Exelon Generation Company, LLC  
Dresden Nuclear Power Station  
6500 North Dresden Road  
Morris, IL 60450-9765

Dresden Nuclear Power Station, Units 2 and 3  
Facility Operating License Nos. DPR-19 and DPR-25

Subject: Request for Additional Information Regarding Risk-Informed Inservice  
Inspection Program Relief Request

**Response to Request for Additional Information  
Alternative to the ASME Boiler and Pressure Vessel Code Section XI Requirements  
for Class 1 and 2 Piping Welds Risk Informed Inservice Inspection Program**

**Figure RAI 12-A Comparison of Inspection Effectiveness Factors for  
EPRI RI-ISI Exams at DNPS Units 2 and 3**

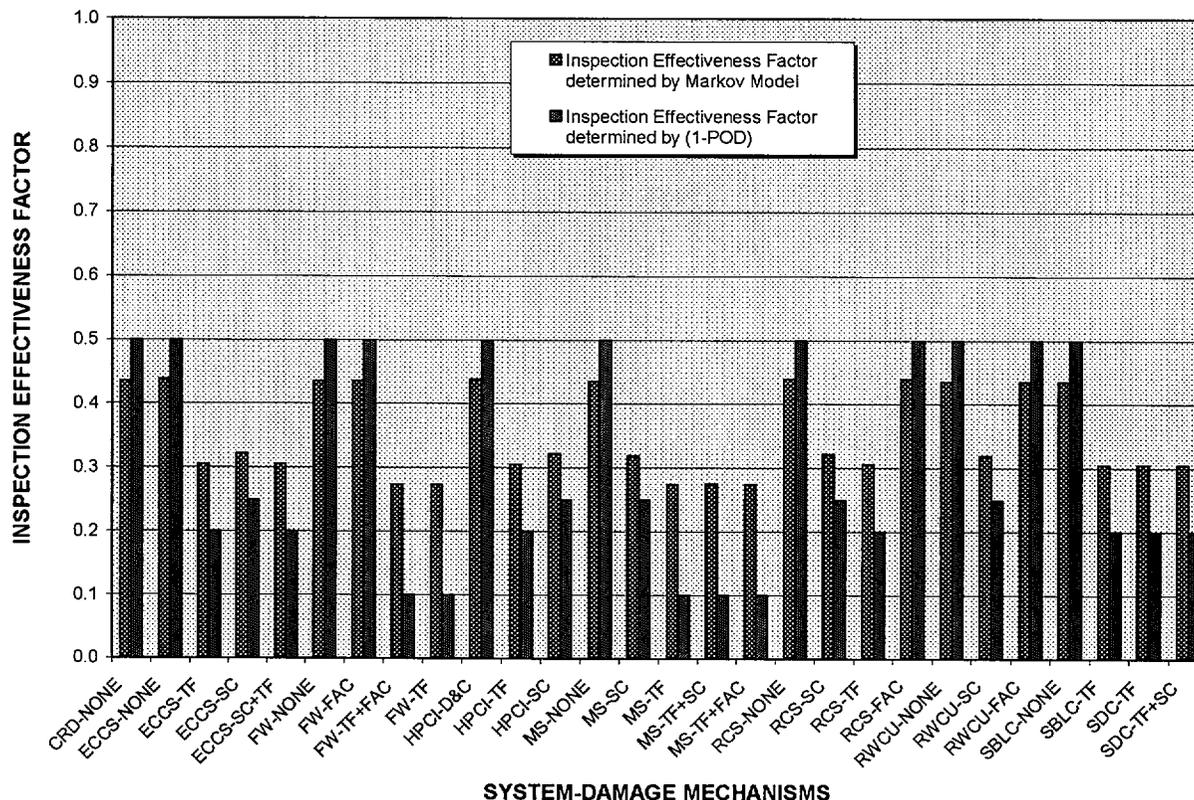
It is our understanding that you are calculating an "inspection effectiveness factor" for use in equation 3-9 of EPRI Topical Report (TR) 112657. Please provide the distribution of inspection effectiveness values calculated (clearly identifying the upper and lower bounds) and a discussion on how these values compare with other probability of detection estimates (redefined to the same format).

A tabulation of all the unique inspection effectiveness factors for all pipe segments evaluated within the scope of the RI-ISI evaluation for DNPS Units 2 and 3 is presented in Table RAI 12-A. For comparison purposes, the corresponding POD values that were used were presented along with their complements that provide the alternative method of computing the inspection effectiveness factor. A plot that compares the two approaches to computing the inspection effectiveness factors is provided in Figure RAI 12-A for the RI-ISI exams.

As seen in these exhibits, there is fairly good agreement between these alternative approaches to estimating the inspection effectiveness factors. When the POD values are around 0.50, the Markov model predicts a somewhat higher level of inspection effectiveness, as reflected in somewhat lower inspection effectiveness factors. For higher POD values, the Markov model predicts a somewhat lower level of inspection effectiveness, as reflected in somewhat higher inspection effectiveness factors. Details documenting the inputs to computing these factors are discussed in response to RAI 11.
